TECHNICAL BULLETIN INDEX
Sorted by Bulletin Number
04/03/86

BULLETIN NO: II:1

PRODUCT: 26-4001/2 Model II

Figure 1

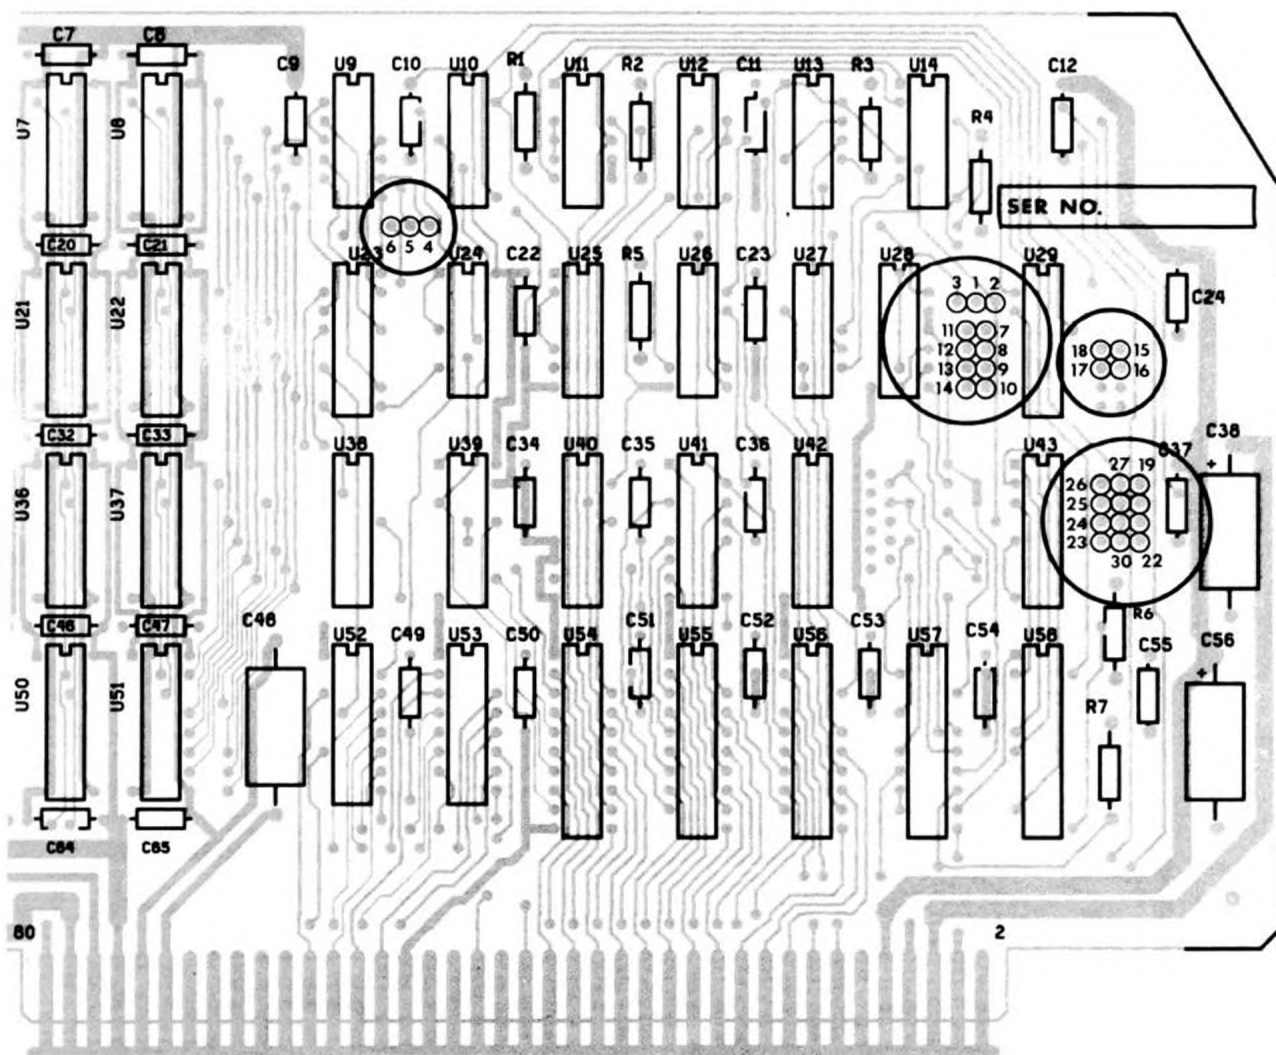
DISCUSSION: There are three possible memory board configurations for the Model II. A 32K Ram board, a second 32K Ram board to upgrade from 32K to 64K Ram, and a single 64K Ram board. Jumper configurations are different for each board.

PROCEDURE: The correct jumper configurations are:

First 32K Memory board:

- 16-17 Selects the first 16K of the base page
- 15-18 Selects the second 16K of the base page

Second 32K Memory board:

- 26-27 Enables the next jumpers on page 1 of the memory map
- 9-11 Selects the first 16K of page 1
- 10-12 Selects the second 16K of page 1

64K Memory board:

- 16-17 Selects the first 16K of the base page
- 15-18 Selects the second 16K of the base page
- 26-27 Enables the next jumpers on page 1 of the memory map
- 9-13 Selects the first 16K of page 1
- 10-14 Selects the second 16K of page 1

The following jumpers are required to be installed on all memory boards.

- 1-2 Pulls up an input to U27 that was floating
- 5-6 Pulls up an input to U9 that was floating

Figure 1

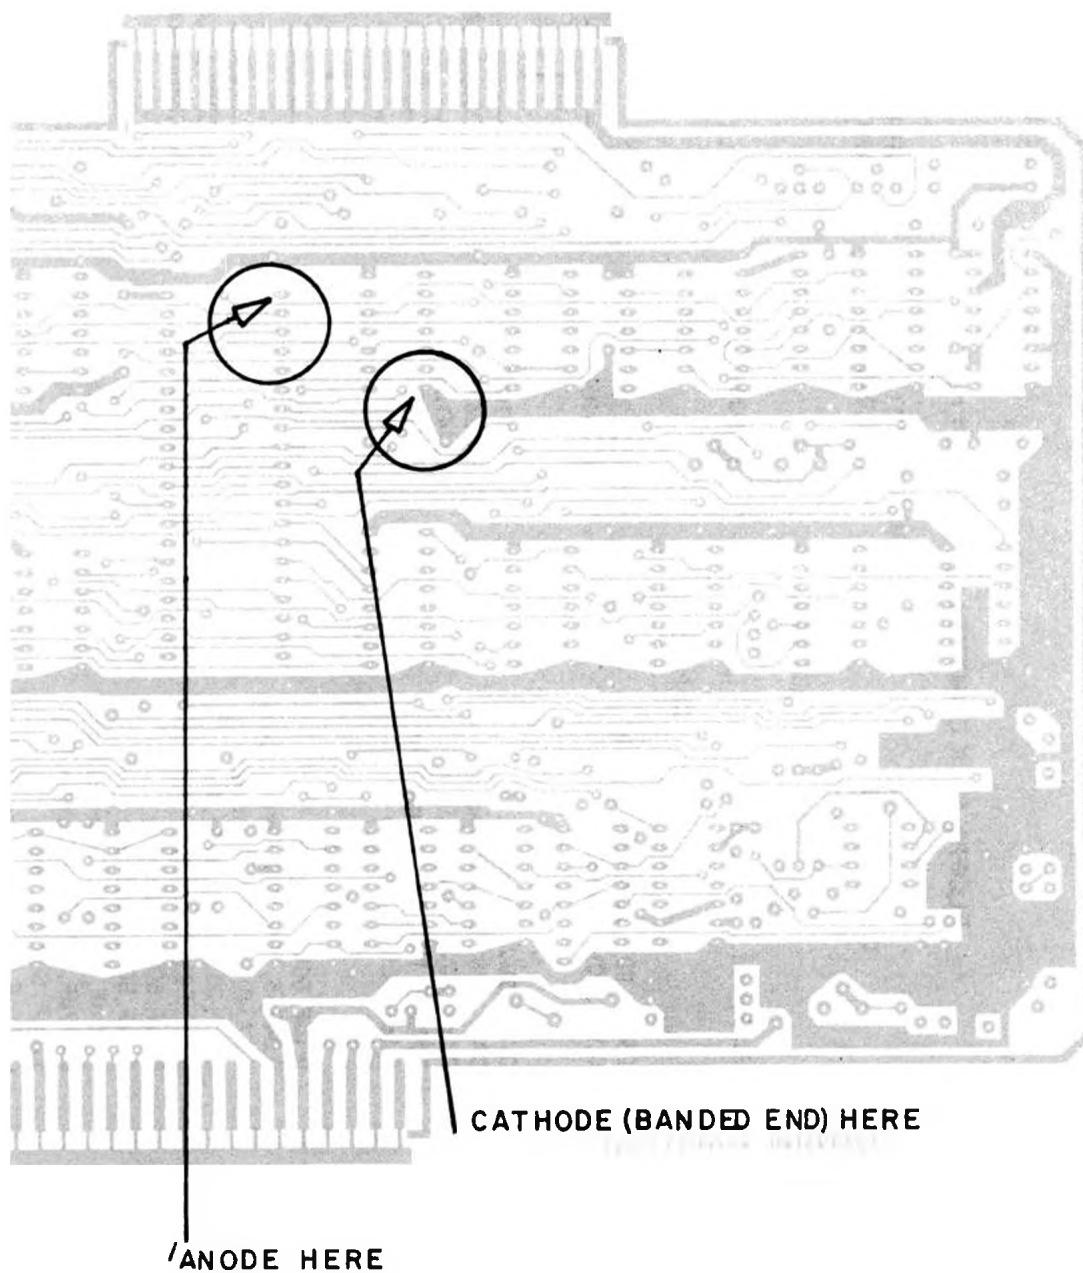
PURPOSE: To correct thermal failure of FDC IC (U6) causing Read/Write errors, and other intermittent disk I/O failures.

DISCUSSION: Early FDC chips developed thermal failures causing disk I/O failures and Read/Write errors. To correct this problem a 2.7V Zener diode MUST be installed from U6 Pin 1 to U5 Pin 7. On new and factory repaired assemblies this change will already have been installed.

PROCEDURE: Check to see if this modification has been done, if not, install diode as per Figure 1. Be sure to use sleeving for insulation of leads to prevent shorts. This diode can be ordered from National Parts using part number ADX-1382 and catalog number 26-4001.

Figure 1

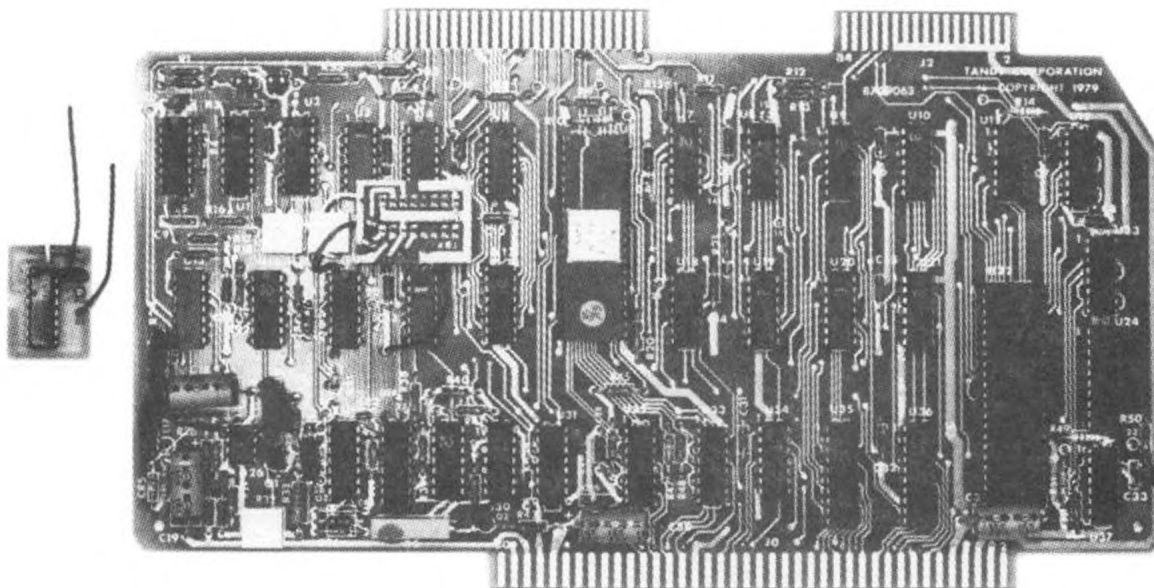
DISCUSSION: Early Design Rev A and B FDC boards require a modification to stretch the write pulse for proper operation with CDC LSI Logic Boards. This is accomplished by adding a satellite board (AXX-0506) to the existing circuitry. Rev C FDC boards have this modification incorporated on them so the modification is not required. To double check the Rev level of the board locate R49. On Rev B boards R49 is located next to the PIO chip (U22) and on Rev C boards R49 is located between U34 and U35.

Figure 1 is a Rev B FDC Board with the satellite board modification.

PROCEDURE: Before performing this modification check the FDC Board in a single drive system to assure it will boot up and format correctly. Be careful not to turn any of the pots R32, R36, and R37 on the FDC board while performing the modification and during installation.

1. Cut trace on foil side of the board running from U3 Pin 1 to U16 Pin 3.
2. Dress red, black, and white wires coming from the satellite board to follow the routing shown in Figure 1.
3. Remove solder from the PCB pad that is to receive the stake pin. This is the pad connected to U16 pin 3.
4. Invert satellite module, insert stake pin, and solder the stake pin into place.
5. Reflow solder in unused PCB pads while inserting tinned satellite module leads as shown in Figure 1.
6. Align the FDC board as outlined in the FDCALG diagnostic alignment procedures. Alignment is MANDATORY after performing this modification.

Figure 1

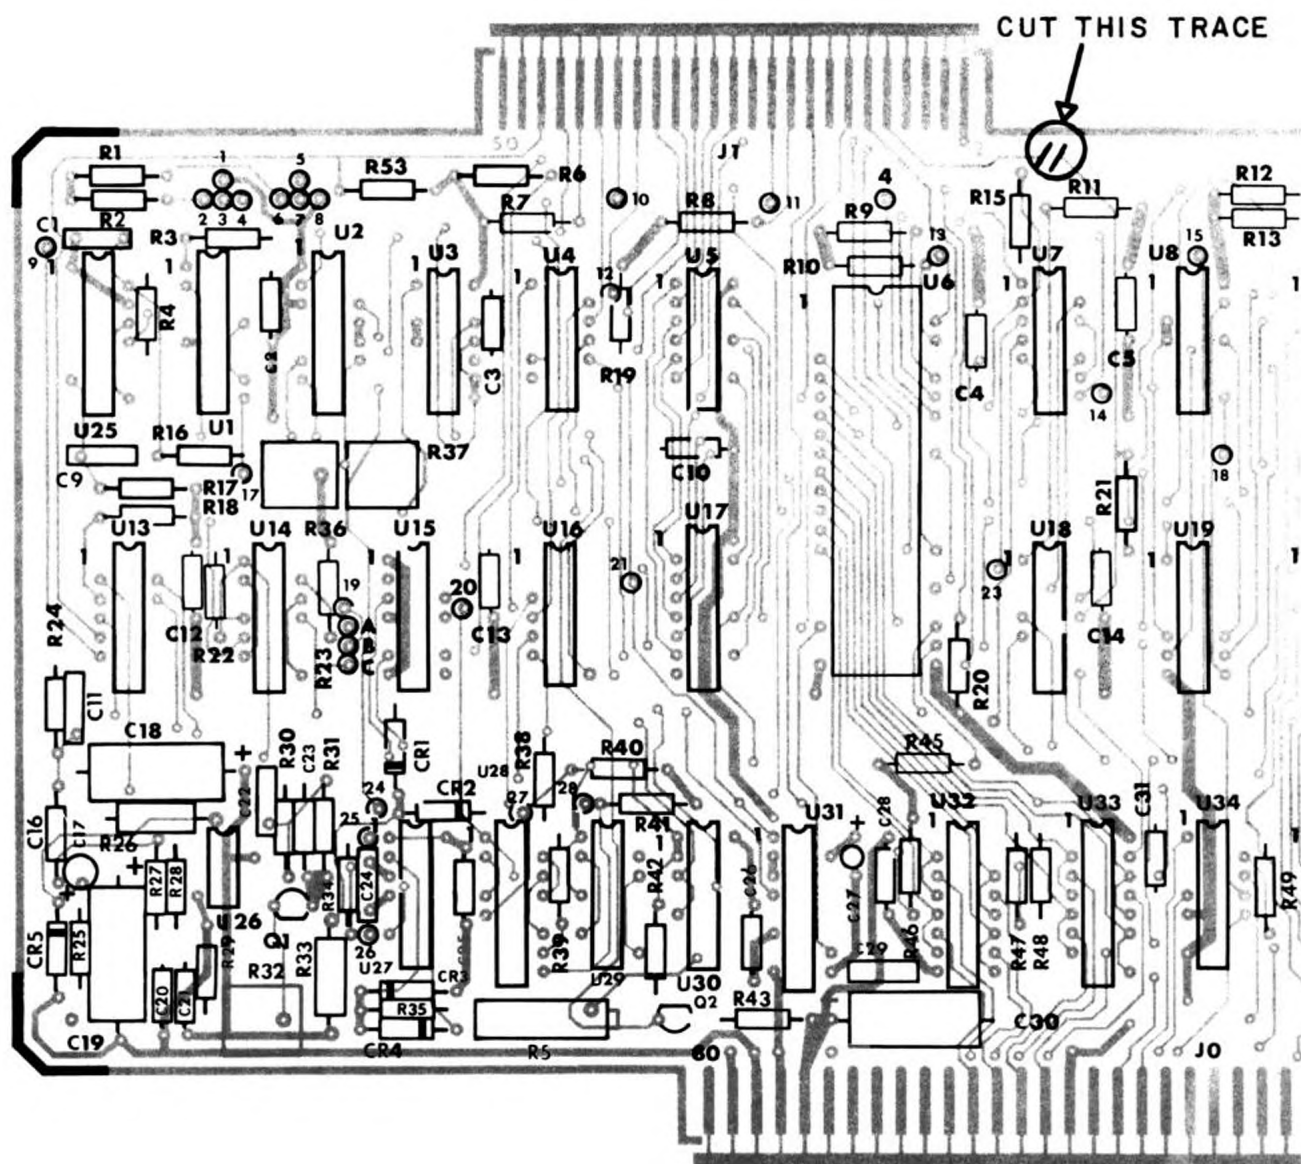
PURPOSE: To prevent Xenix from thinking there is a double sided disk in drive 0 when a terminator is used.

DISCUSSION: The terminator that is used with the Model II ties pin 10 of the disk drive card edge to pin 34. This takes the direction line (pin 34) and connects it to a previously unused line (pin 10) which has a pullup resistor R21 installed on it. Xenix looks at pin 10 to determine if the diskette in the current drive is single or double sided. With the terminator installed this signal will change depending on the direction the drive was last stepped. To correct this problem the trace connected to pin 10 of the FDC board should be cut. This will prevent the customer from being able to use double sided drives, which Radio Shack does not support in the Model II. This modification should only be done to Model IIs that have the 26-6010 enhancement kit installed and an old style FDC board.

PROCEDURE: Locate and cut the trace connected to pin 10 of the disk drive connector on the FDC board (Refer to Figure 1).

Figure 1

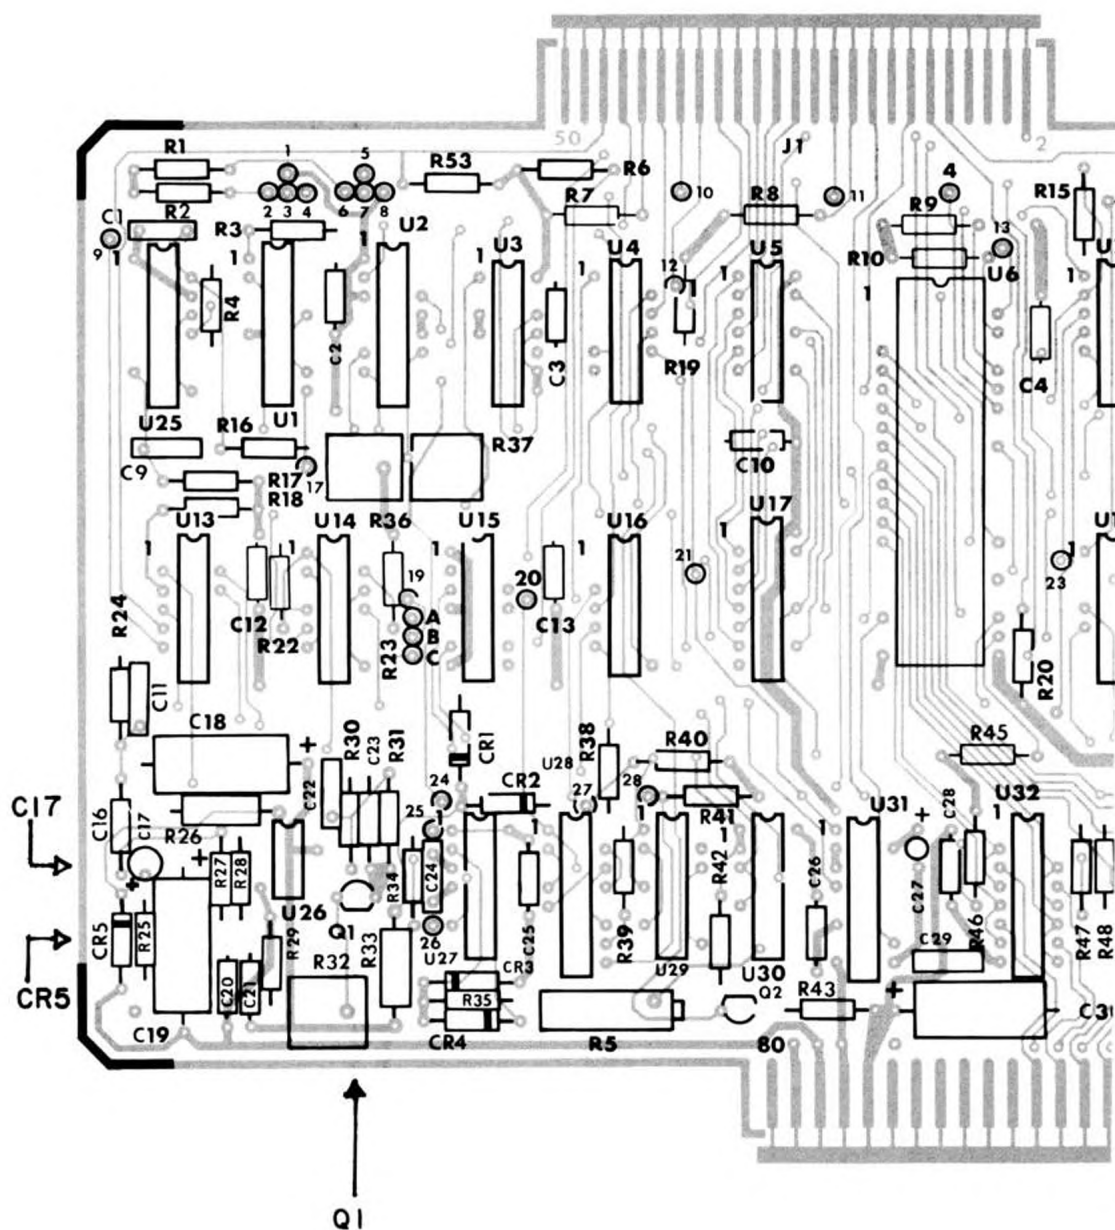
PURPOSE: To correct FDC Boards which have C17 installed backwards.

DISCUSSION: Early FDC boards had a problem with C17 installed backwards. Rev A boards were not marked with polarity. Rev B boards and early Rev C boards were marked with the polarity backwards. This problem was corrected on later Rev C boards. C17 is a .47 ufd tantalum capacitor with a 33V rating. Installed backwards it will eventually break down due to approximately -6V across the capacitor. Note that CR5 is referenced to -12V. This capacitor installed backwards can cause intermittent problems and will eventually cause circuit failure. Over a period of time the capacitor will smoke causing CR5 and possibly Q1 to be damaged.

PROCEDURE: Check C17 on all units in for service to insure the positive(+) lead is going to ground. The most accurate method of checking this is by actually checking with an ohm meter continuity between the positive lead of C17 to ground. If capacitor is installed backwards replace with a new .47ufd tantalum capacitor(ACC-474MGTP). Do not just turn the old capacitor around as it has started degrading and life expectancy shortened.

If the capacitor actually smoked then you must replace it and the diode CR5 (ADX-1279). Also check Q1, a 2N2222A transistor (AMX-4263), because it may have been damaged also, replace if necessary.

FIG. 1

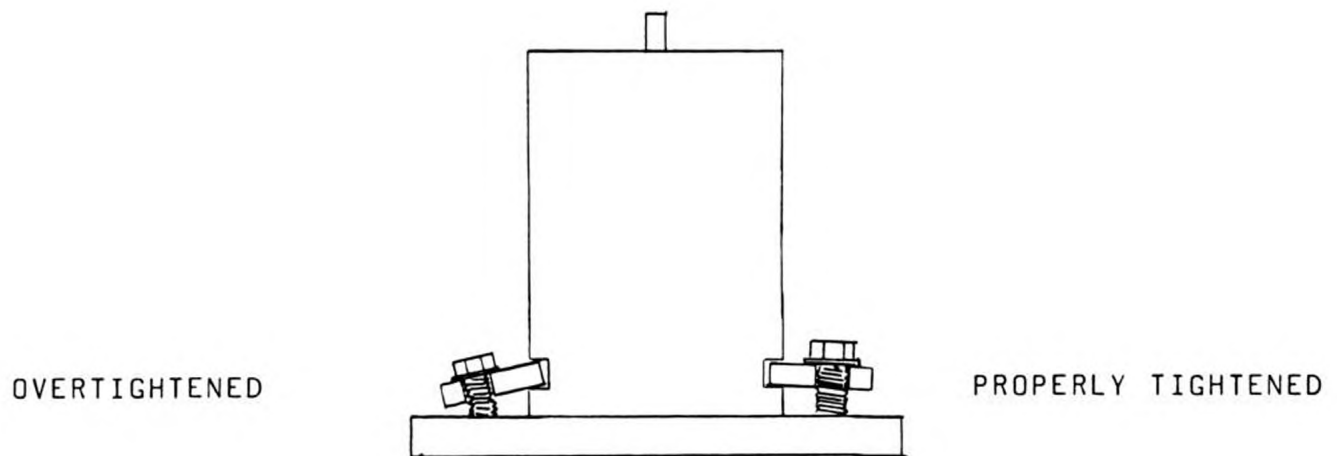
PURPOSE: Explain proper tightening of stepper motor bracket screws after Head Radial Alignment.

DISCUSSION: After aligning Head Radial DO NOT OVERTIGHTEN bracket screws when securing the stepper motor. Excessive tightening will cause bracket and screws to bend and eventually damage the screw holes in the stepper motor plate, making proper alignment almost impossible.

PROCEDURE: After Head Radial Alignment tighten bracket screws only enough to secure stepper motor. If the stepper motor cannot be secured without excessively bending the bracket (Refer to Figure 1), or if the screw holes in the plate are damaged, replace the drive chassis.

FIG 1

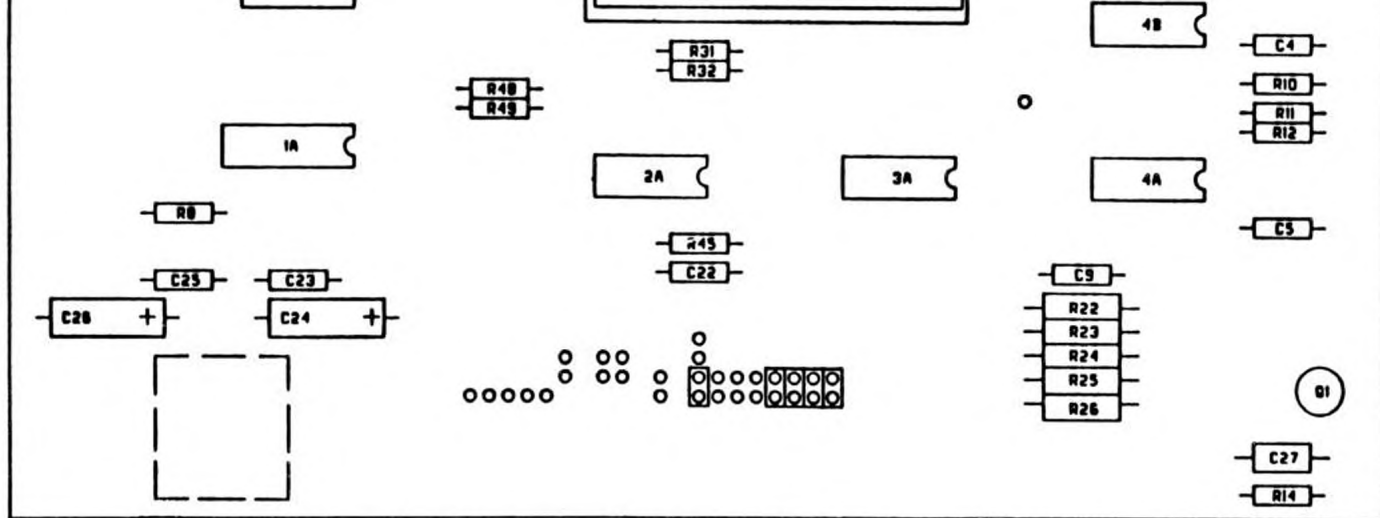
PURPOSE: To correct problem of getting Boot Error DC usually after running Scripsit.

DISCUSSION: This problem will occur only on a small percentage of Model IIs and the solutions should be used to resolve specific customer complaints. There are two solutions to fix this problem:

1. Addition of a .47 ufd 35V tantalum cap across C21 in the power-on-reset circuitry. This will insure power-up in a valid phase of the stepper circuitry.
2. Proper adjustment of the track 00 stop.

PROCEDURE: SOLUTION 1: Check board to insure .47 ufd capacitor is installed across C21 (Refer to Figure 1). This capacitor should be on all LSI boards, if not present, install capacitor with negative lead going to ground. Any value from .47ufd to .68ufd is acceptable. ACC-474MGTP is the National Parts Number for a .47ufd 35V capacitor. Later boards had the capacitor value at C21 changed.

Figure 1

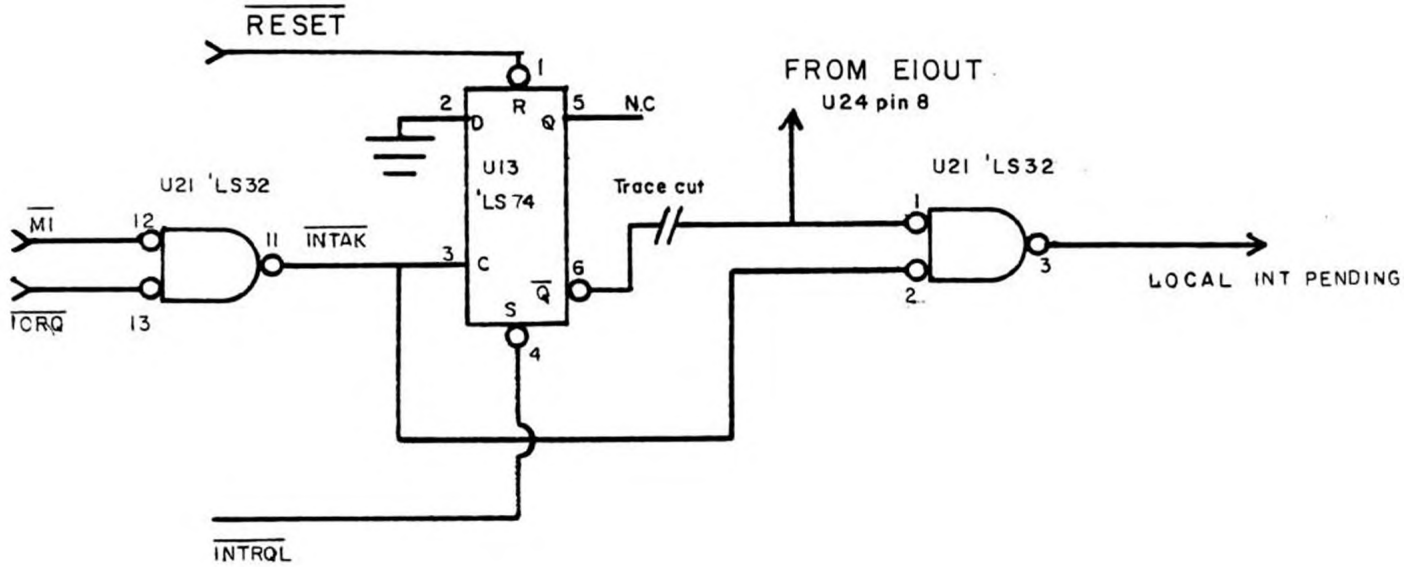
DISCUSSION: The Bisync modification is to allow the TRS-80 to communicate with other computers that use the Bisync communications format. This modification affects Channel A only and does not affect Channel B and its operation with a printer or other software. Both in async (normal) and Bisync modes a terminator is still required for the unused channel.

Refer to Figure 1 for schematic changes affected by this modification. The signal Local Interrupt Pending is now ANDed with EIOUT, and not with INTRQL. Previously, if the SIO programming was changed with interrupts disabled, a local interrupt could set flip-flop U13 without being serviced. Later, when an off board interrupt occurred, the bus steering logic would mistakenly interpret this as an on-board interrupt and would not turn the external data receive buffers. By ANDing the EIOUT signal with INTAK signal this problem is eliminated.
